PLAN 2

The Holly - RH

LOT 17 Heritage at Neills Creek

21 Whistling Way
Lillington, NC 27546

SHEET
2.1.1a

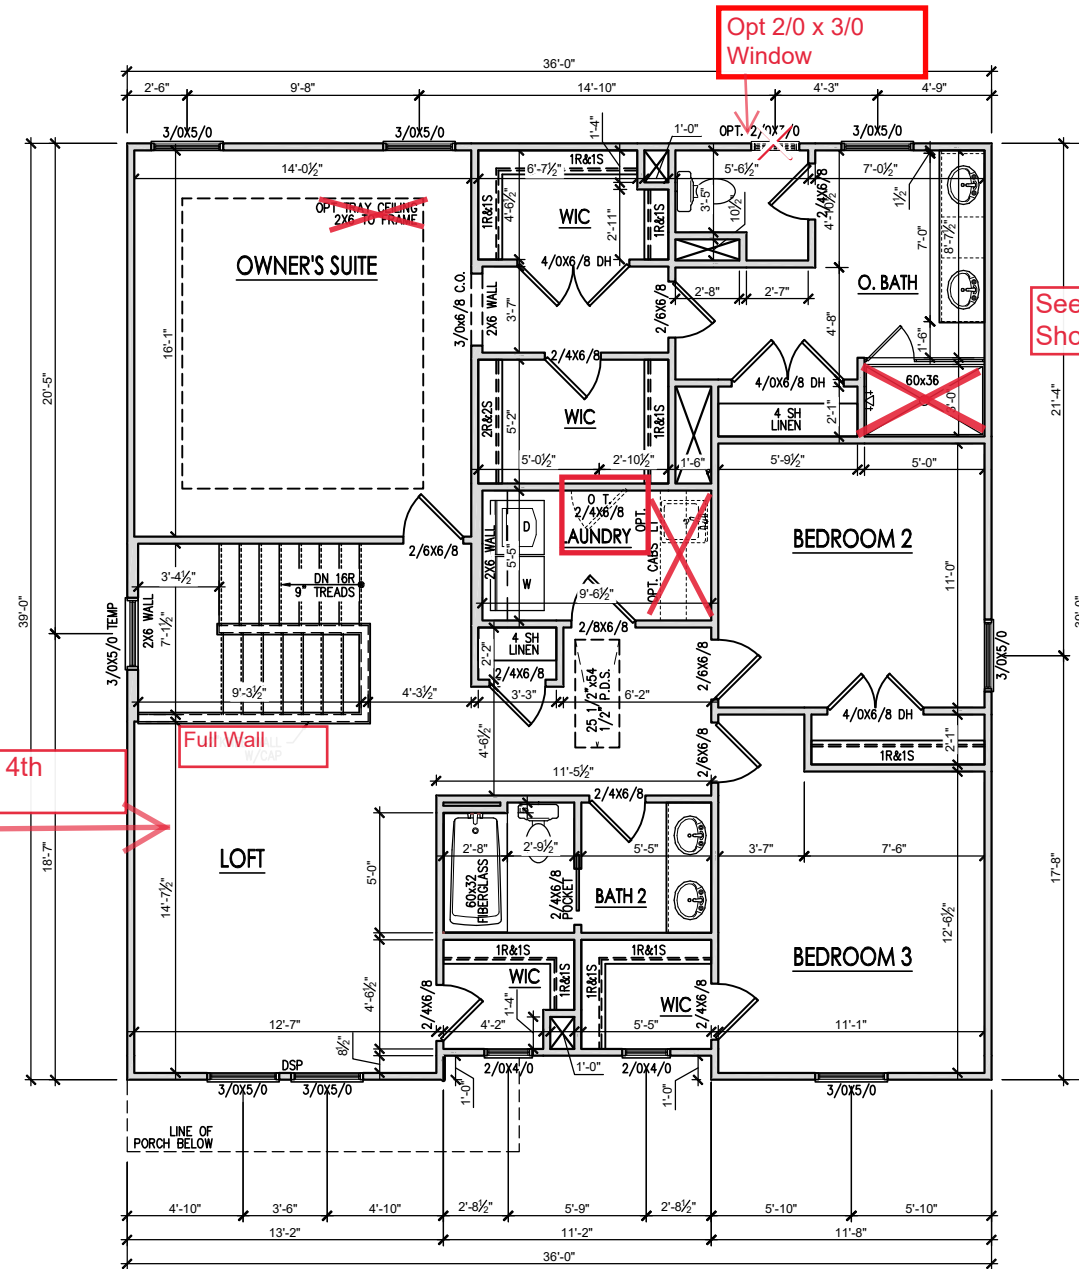
Make this Smart Door Delivery a LH door and swing 'in'

Reduce this offset from 3'-6" to 2'-0"

Opposite Door

Left In Swing both Exterior Doors
